# Paterson Redevelopment Project

## Design and Access Statement Addendum

The application for full planning permission (reference 123748/FO/2019 ) for the erection of a part 7-storey and part 10-storey building ("the Paterson Redevelopment Project" and / or "PRP") at The Christie Withington site was approved in August 2019.

An application for a non material amendment (reference 128432/NMC/2020 ) to allow for amendments to the external appearance was approved in December 2020.

Drawing reference PRP-BDP-Z01-00-PL-A-9001 - External Compound Layout  
Revision P01

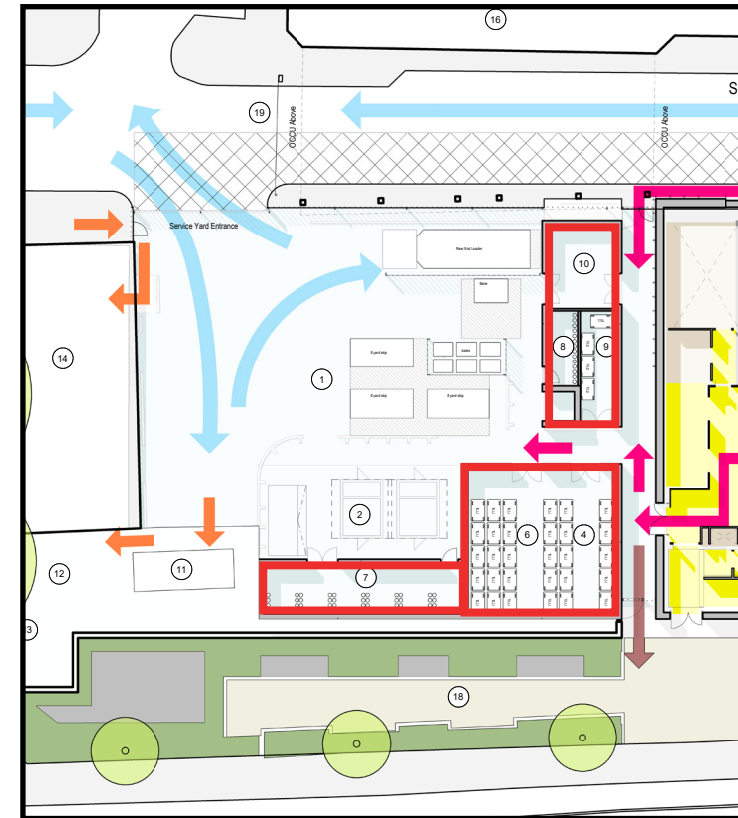
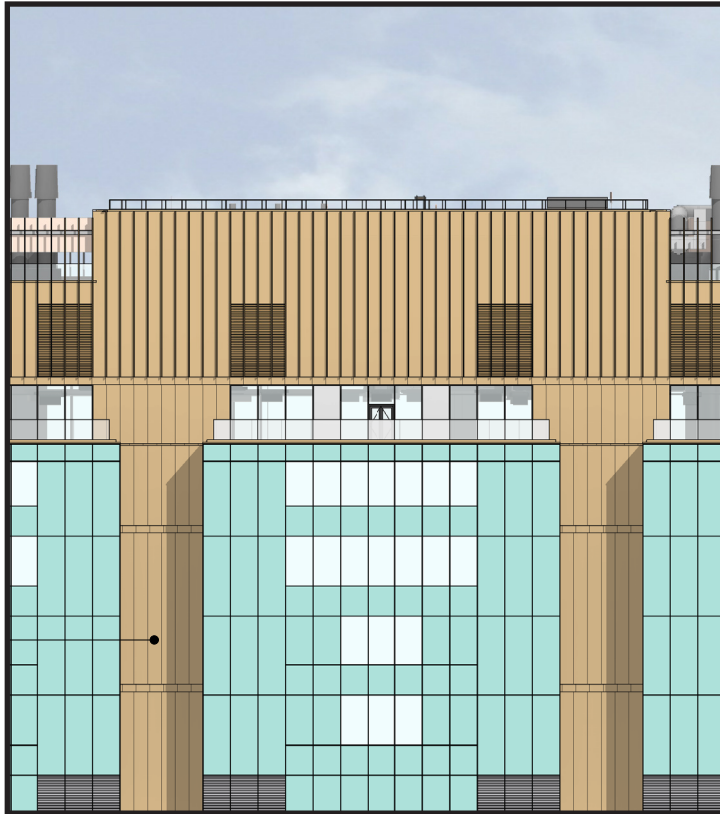
Through development of the external waste storage with the stakeholder groups there has been a reduction in the footprint of the compound. Storage within the compound structure has been offset against space created within the service yard for dedicated Space for prefabricated Solvent / Chemical Waste Store which have a smaller footprint than being contained within the compound structure.

Approved outline of external compound highlighted with red outline.

Proposed reduced outline of external compound highlighted with red outline.

Drawing reference PRP-BDP-Z01-XX-EL-A-2194 - West Elevation  
Revision P03  
Approved elevation.

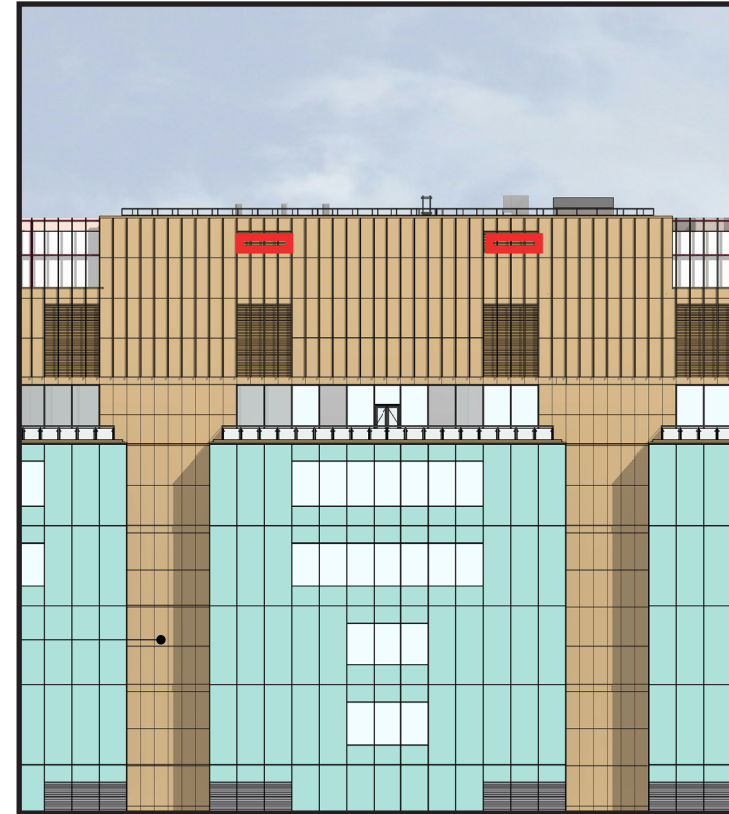
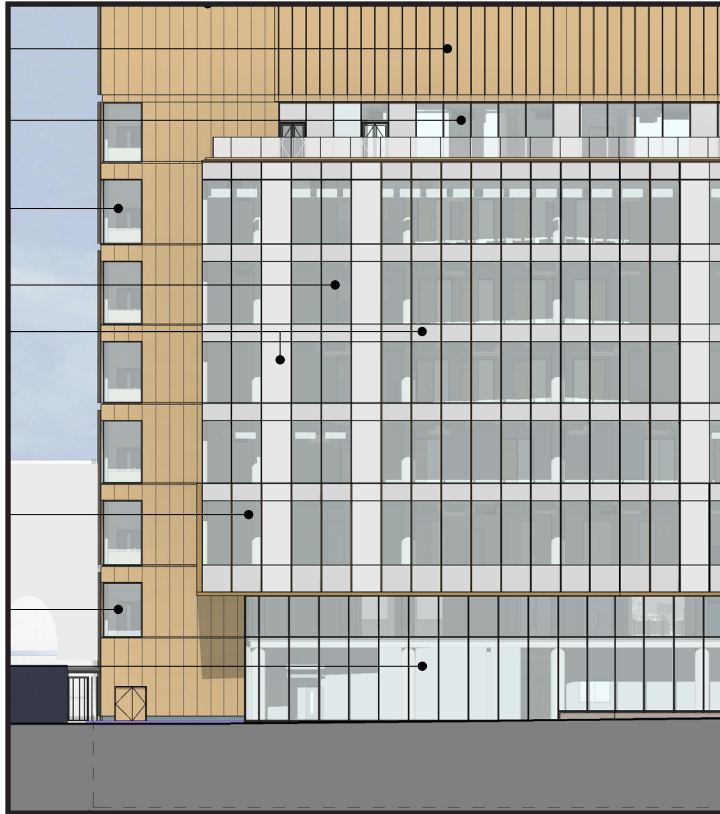
The completed building services design has required additional louvres that were not allowed for in the original application. These are at Level 09 on the West elevation. The introduction of these have been considered to ensure the original design intent remains with all louvres finished in RAL 1035 to colour match anodised finish to rainscreen cladding.

Drawing reference PRP-BDP-Z01-XX-EL-A-2194 - West Elevation  
Revision P05  
Proposed additional louvres at level 09 in RAL 1035 to match all  
louvres set in anodized rainscreen.

Drawing reference PRP-BDP-Z01-XX-EL-A-2191 - East Elevation  
Revision P03  
Approved elevation treatment to ground floor.

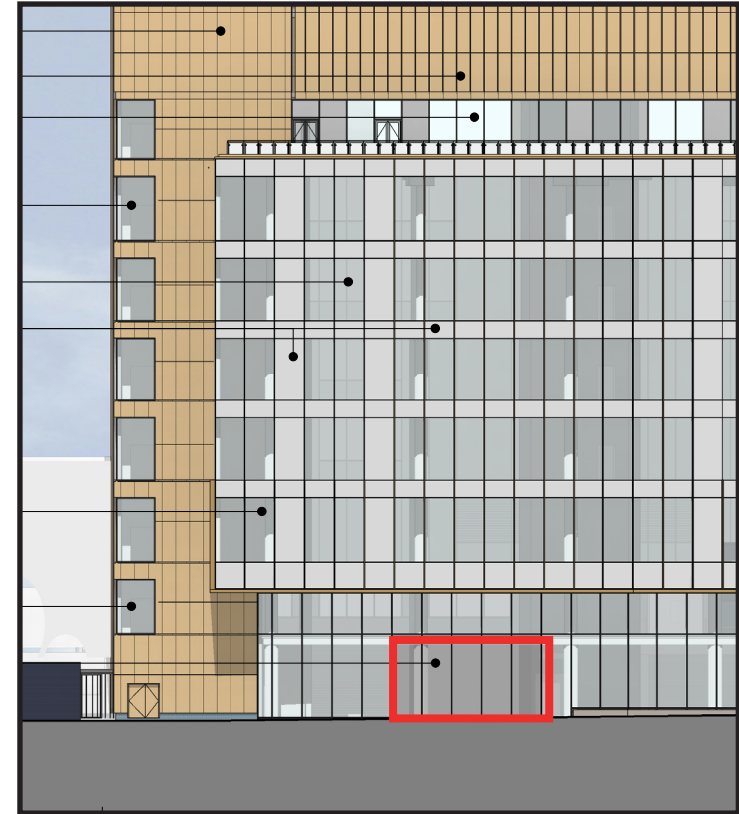
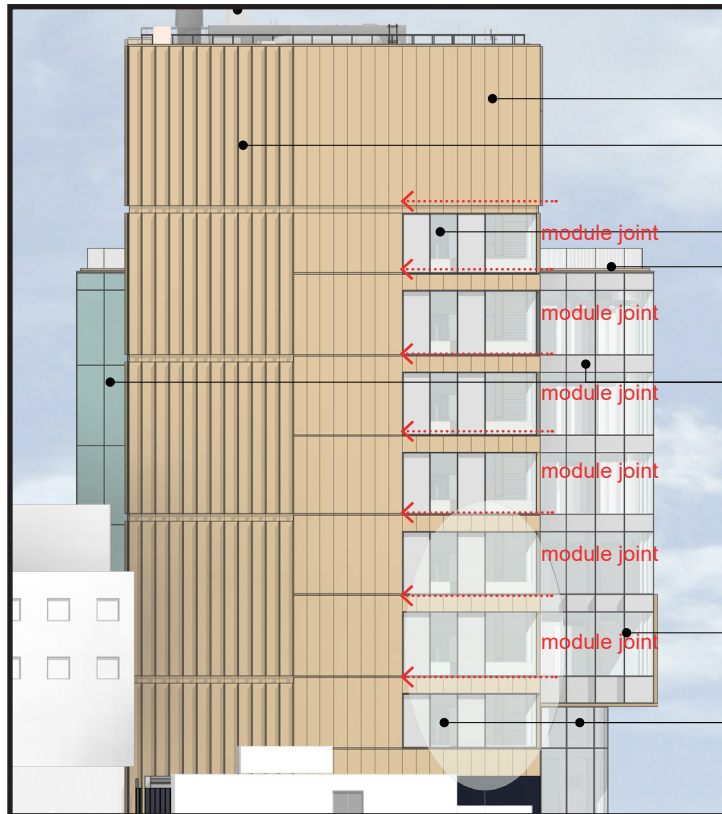
Through development of the internal spaces with the Stakeholder groups a space integral to the function of the department has identified an area requiring privacy along the facade. Glazed spandrel panels have been introduced similar to glazed spandrels provided on the East elevation.

Drawing reference PRP-BDP-Z01-XX-EL-A-2191 - East Elevation  
Revision P05  
Proposed introduction of spandrel panels.

Drawing reference PRP-BDP-Z01-XX-EL-A-2193 - South Elevation  
Revision P03  
Approved vertical cladding module with panel joint at floor level

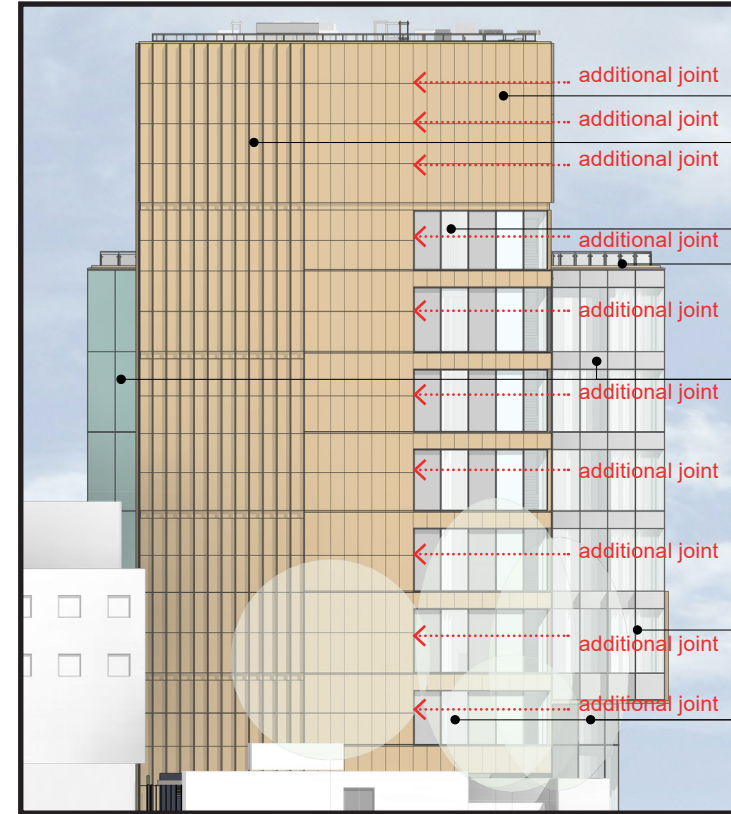
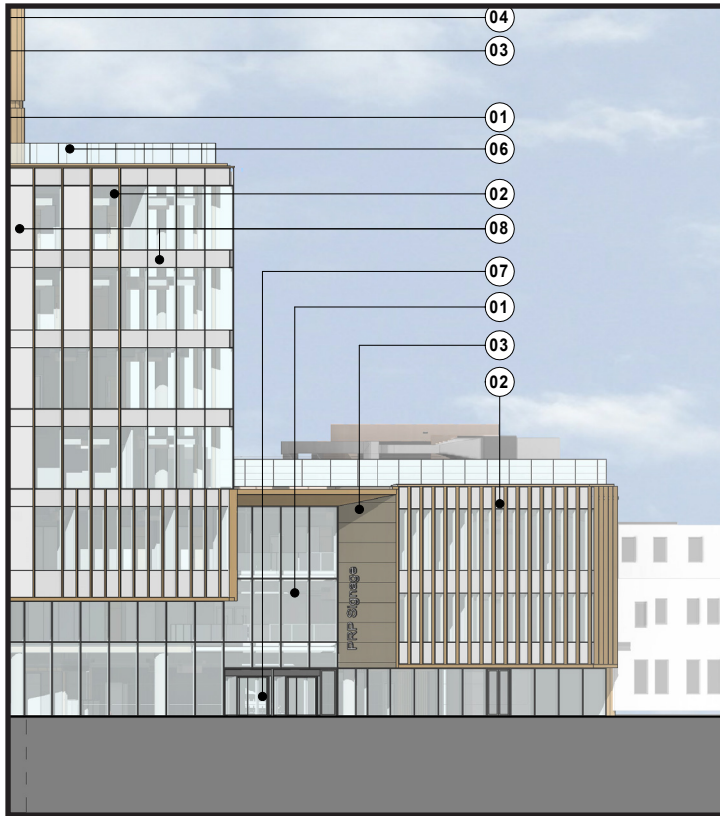
Within the original application the vertical anodised rainscreen cladding finished in Analok 541 had a horizontal joint at floor level. An additional horizontal joint has been introduced centred between the floor level joints. Building elevations will now have a more human scale to them with a more refined vertical clad module of circa 2m+ in length the elevations will still retain a scale appropriate to the building.

Drawing reference PRP-BDP-Z01-XX-EL-A-2193 - South Elevation  
Revision P05  
Proposed additional horizontal joint within vertical anodised cladding module.  
Finished in Analok 541

Drawing reference PRP-BDP-Z01-XX-EL-A-2191 - East Elevation  
 Revision P03  
 Approved elevation

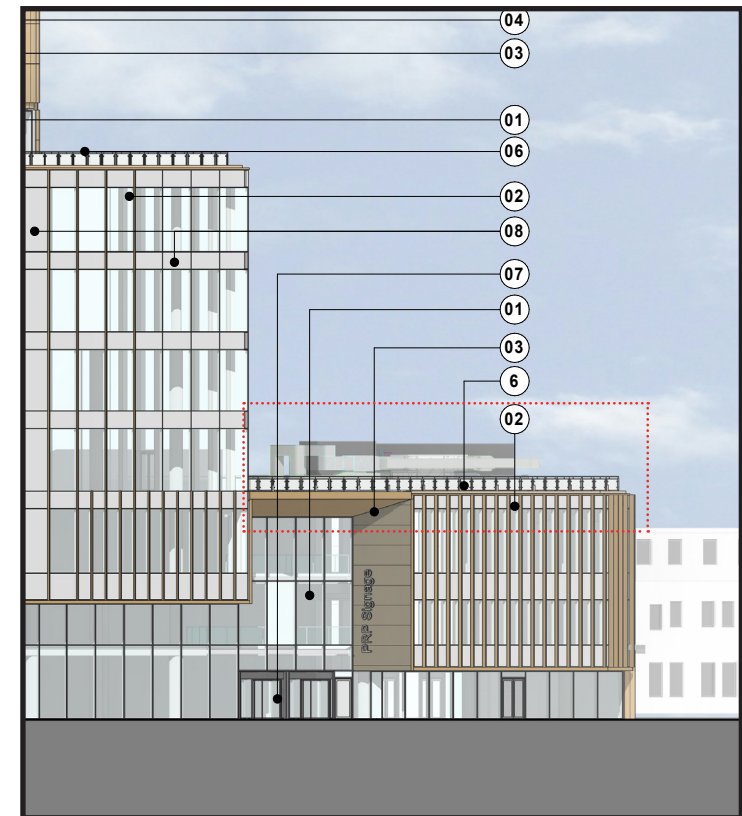
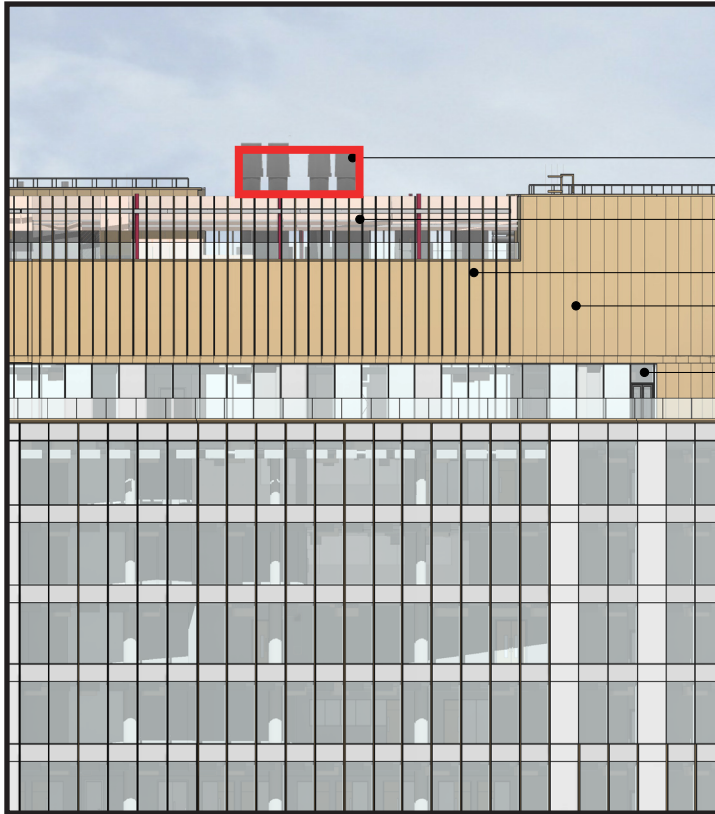
Previous submitted and approved drawings provided the ongoing building services design at rooftop levels. The services design has been developed further with the current design indicated. The external balustrade is as per submitted proposals as part of Condition no. 4.

Drawing reference PRP-BDP-Z01-XX-EL-A-2191 - East Elevation  
 Revision P05  
 Proposed rooftop building services to level 03.

Drawing reference PRP-BDP-Z01-XX-EL-A-2191 - East Elevation

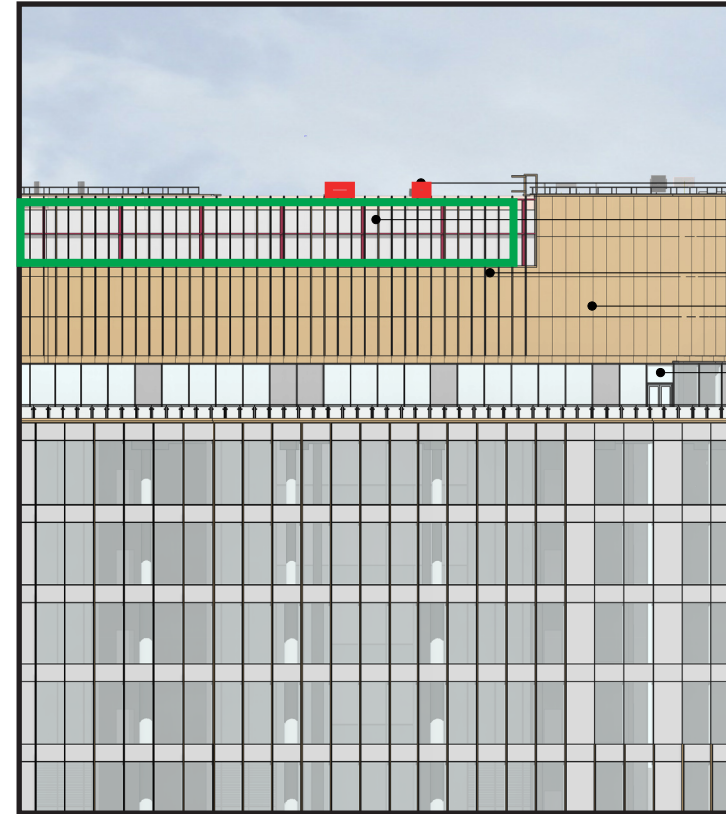
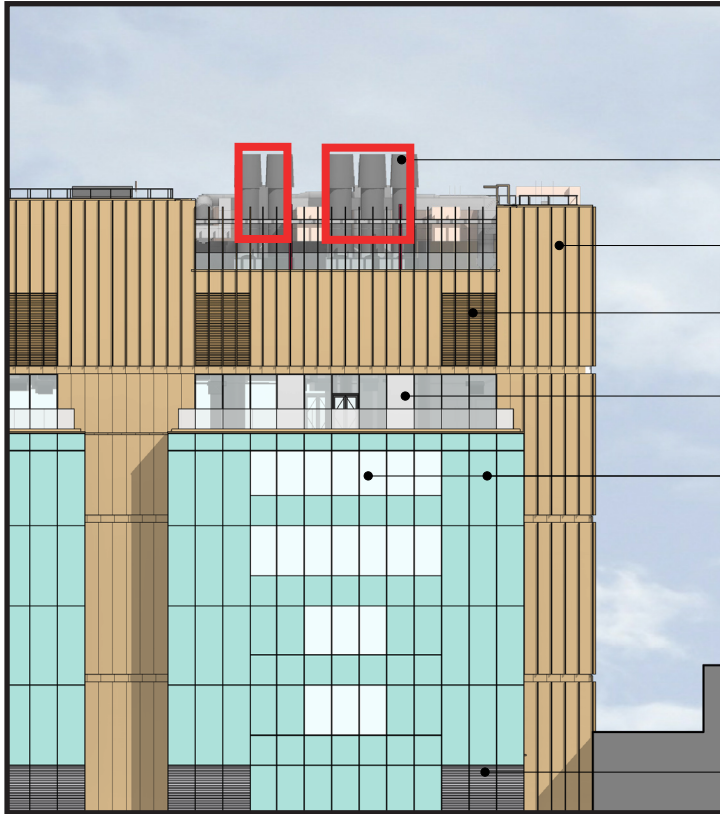
Previous submitted and approved drawings referenced the ongoing building services design at rooftop levels. The services design has been developed further with the current design indicated. The proposed external balustrade is as per submitted proposals as part of Condition no. 4. Design development of the strobic fan/ flue reduced the height of these and their visual impact.

The project Acoustic Consultant reviewed the developing building services design and identified a requirement to screen the rooftop services with an aluminium acoustic screen where there was previously open 'cut-outs' within the elevation. The benefit of this was that the building services would no longer be visible, the screen was set back from the building perimeter with a contrasting finish so the original massing intention was retained.

Approved elevation with exposed plant services to level 09 including strobic flue / fans.

Proposed acoustic screen in RAL 9018 to level 09 indicated in green.  
Note this runs along the length of the East elevation at level 09.

Drawing reference PRP-BDP-Z01-XX-EL-A-2194 - West Elevation  
Revision P03

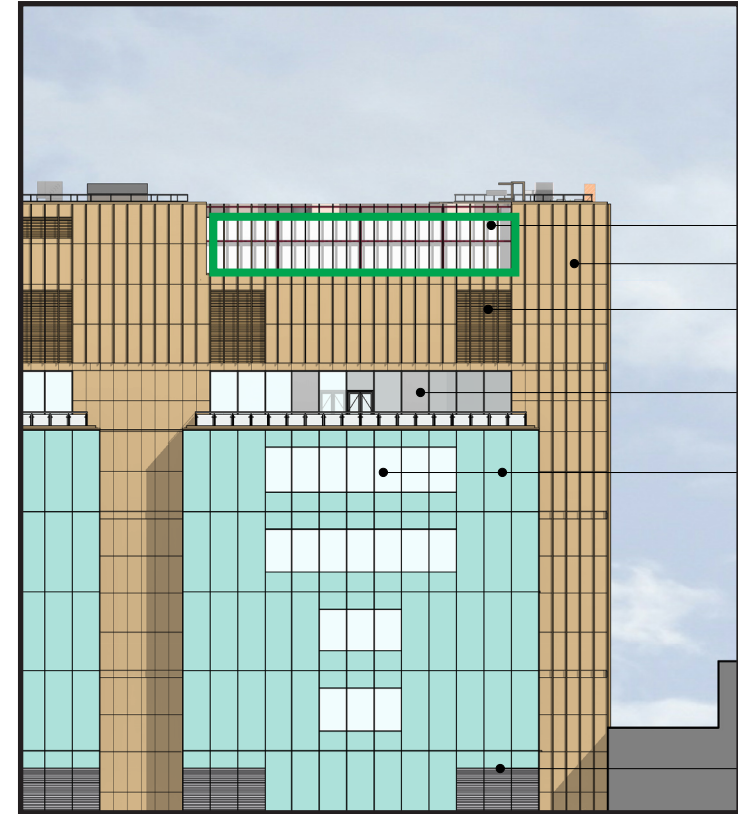
Approved elevation with exposed plant services to level 09 including strobic flue / fans.

Proposed acoustic screen in RAL 9018 to level 09 indicated in green.  
Note this runs along the length of the West elevation at level 09.
